1978 Corvette: Service Bulletin: Removable Roof Panel Fit

Subject: Removable Roof Panel Fit
Model and Year: 1978 Corvette
Source: Chevrolet Dealer Service Technical Bulletin
Bulletin No: 78-T-23
Section: I
Date: April, 1978

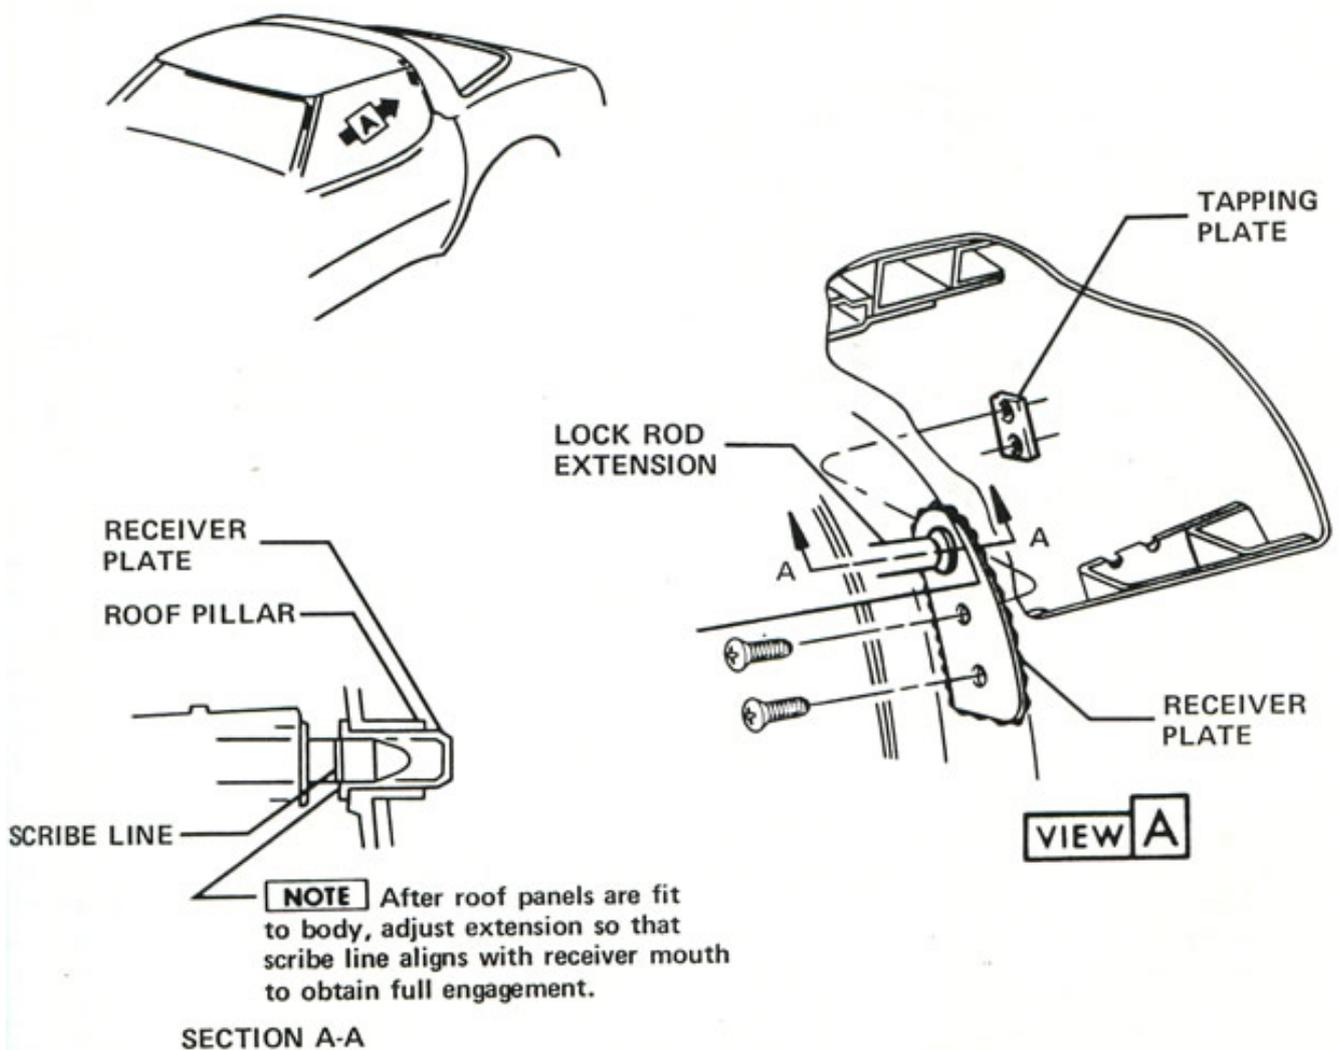
Some early 1978 Corvette removable roof panels may be bowed in relation to the windshield header and/or rear roof. This condition can be caused by an improperly positioned roof lock receiver plate.

1. Remove the rear roof corner garnish and lower roof trim panel.
NOTE: It is not necessary to remove the shoulder belt or retractor.
2. Remove the roof lock receiver plate screws. Hold the tapping plate, located behind the roof pillar, to prevent it from falling (see illustration on page 2). Remove any excess sealer from pillar and receiver plate.
3. Using a small round file, elongate (lower) the three holes in the roof pillar as required to obtain a relaxed roof panel with a flush fit. This will be a trial and error process of installing the receiver plate and checking that the roof panel lock rod extension engages easily.

The bow in a roof panel can be eliminated by lowering the roof lock receiver plate as outlined below:

4. When an acceptable roof panel fit is achieved, thoroughly pack the area behind the receiver plate with 3M Strip-calk or equivalent.
5. Reinstall interior trim panels.
6. Adjust the door glass to the roof weatherstrip as described in Section 2D, 1978 Service Manual.
